REMARKS

USPA No.: 10/825,678

SKETCH 1. Toyoshima

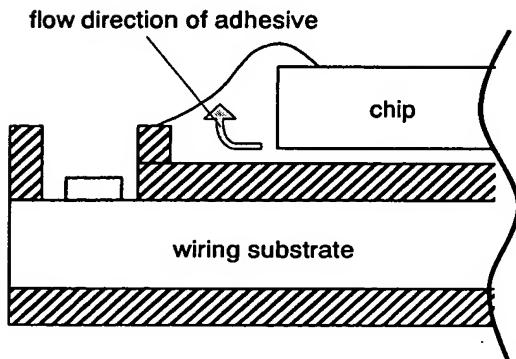
In Toyoshima an edge part of the recess part 13 functions as a dam preventing the outflow of the adhesive 5a. This construction can be used to restrict the flow of adhesive, but it is necessary to secure a sufficient area between the chip and the dam, which is disadvantageous for size reduction.

Compare Toyoshima and the present invention as shown in SKETCH 1 and SKETCH 2 submitted herewith.

SKETCH 2. our invention

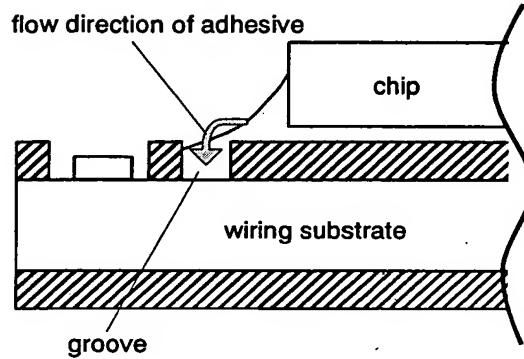
In the present invention, however, the groove extending through the insulating film allows the pasty adhesive outflow to stay in the groove, where it does not reach the electrodes or adversely affect the chip bonding operation.

FIG. 34 PRIOR ART

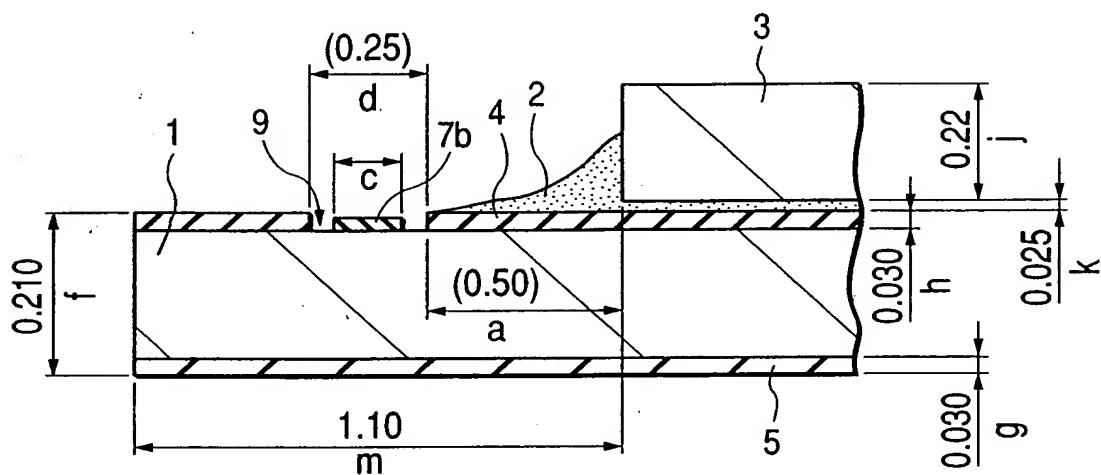
The objection to the drawings has been overcome by labeling Figs. 34-37 as Prior Art and by extending the lead line from reference character 1 in Fig. 34.

The attached sheets of drawings include changes to Figs. 34, 35, 36 and 37, and replace the corresponding original sheets of the drawings. In Figs. 34, 35, 36 and 37, "Prior Art" has been added. The lead line from "1" in Fig. 34 has been extended.
